CHARLESTON RAINBOW UNIT 1
 PUMP STATION

Sheet
 15
 of 15

PLAN

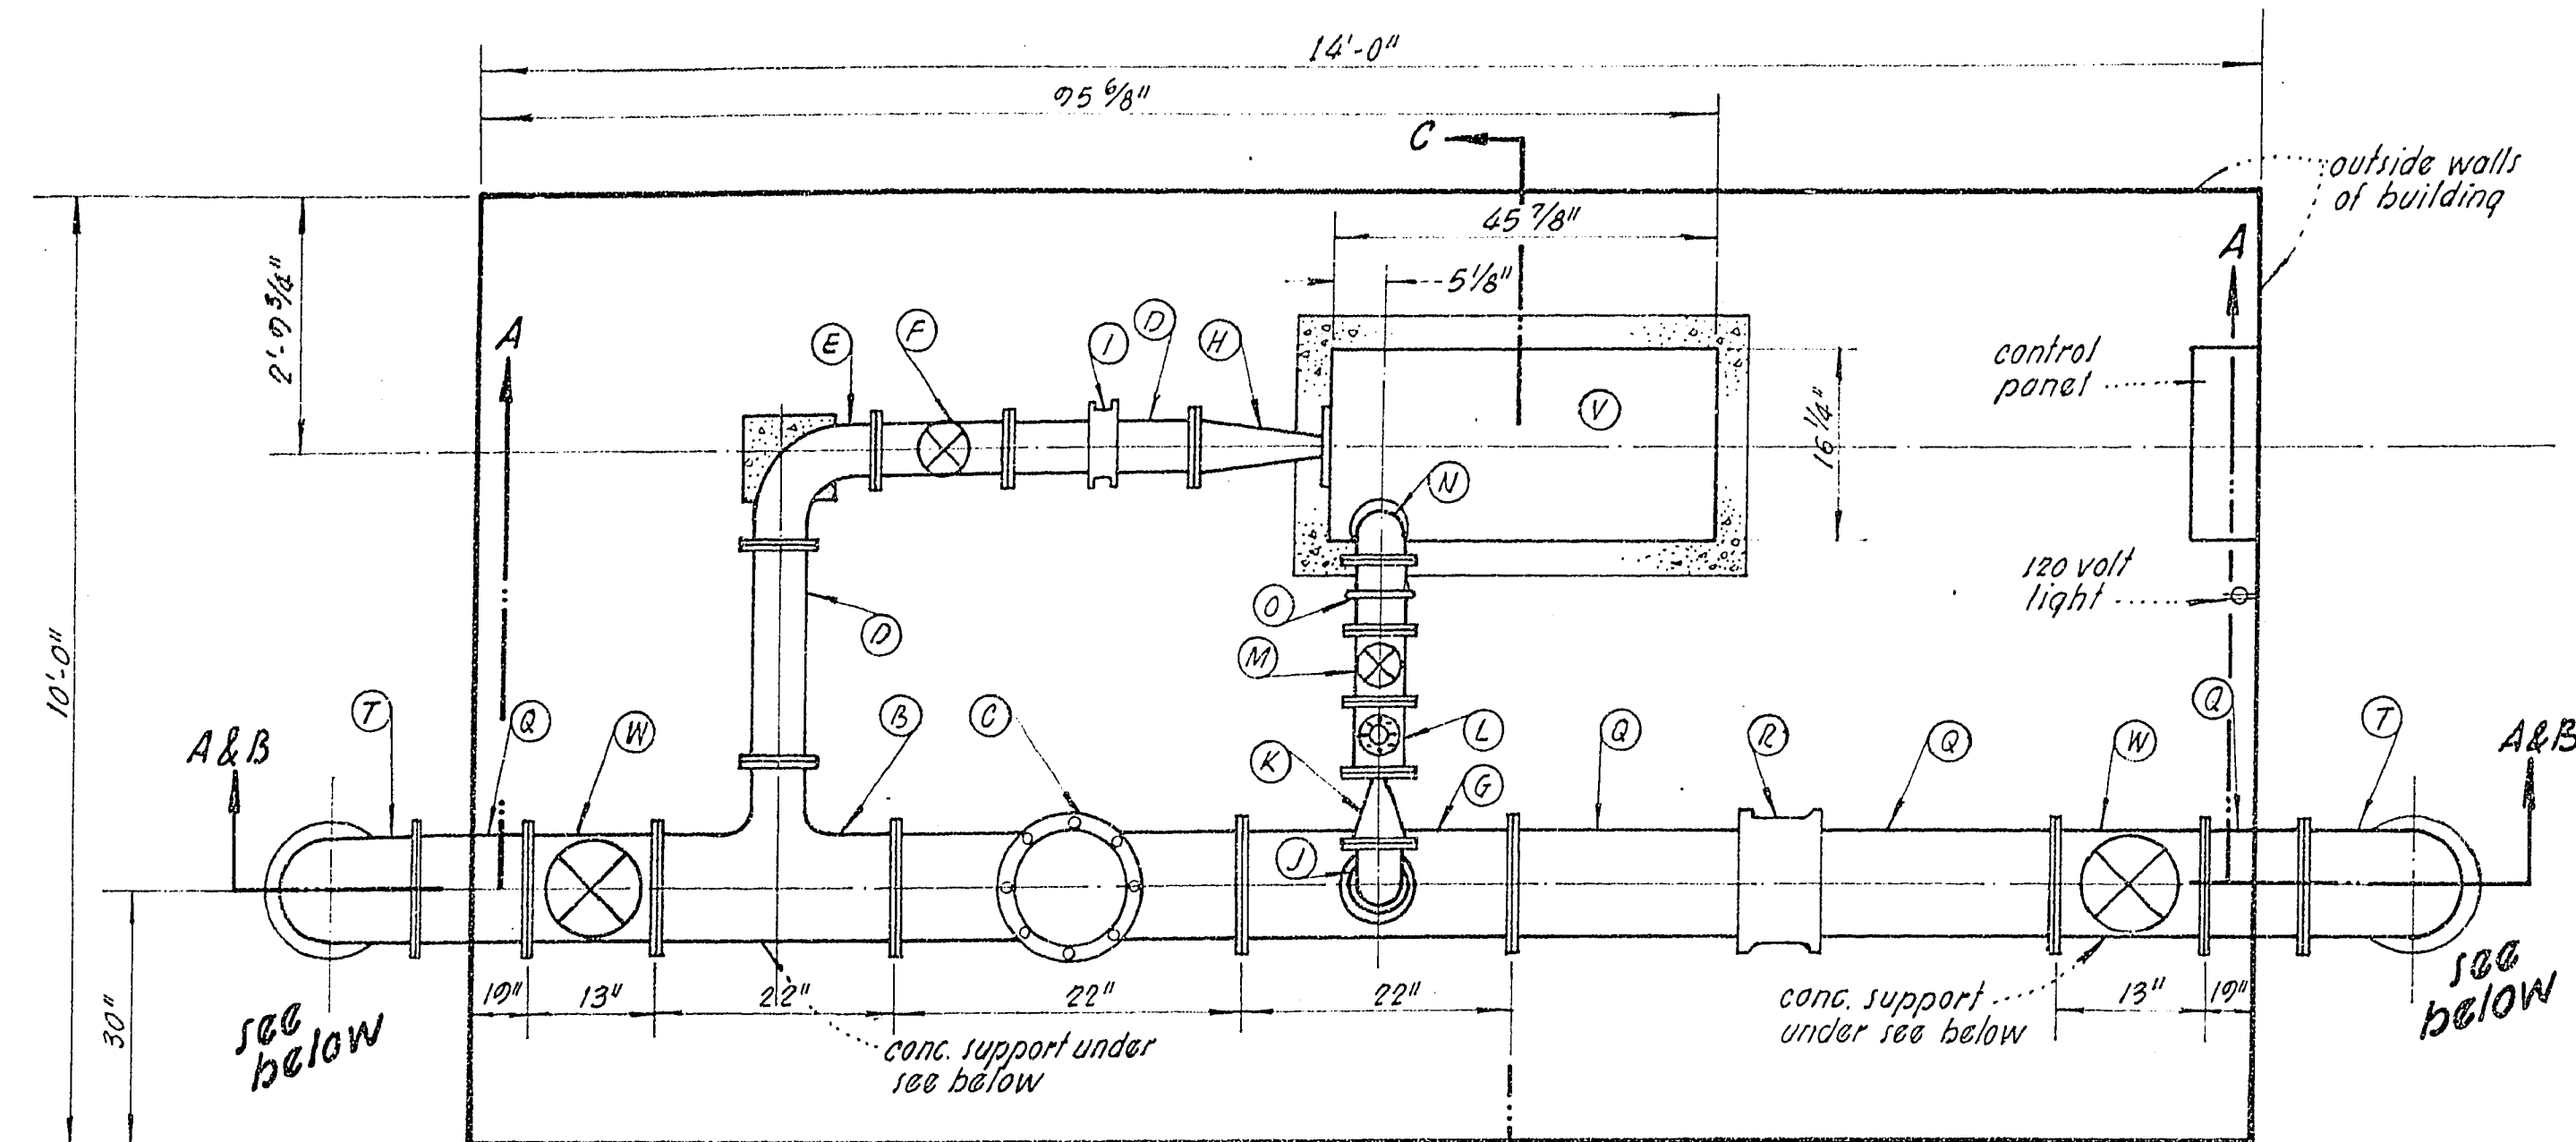
Note: Approved subject to provision of pumping equipment which will operate satisfactorily over the range of heads and capacities required.
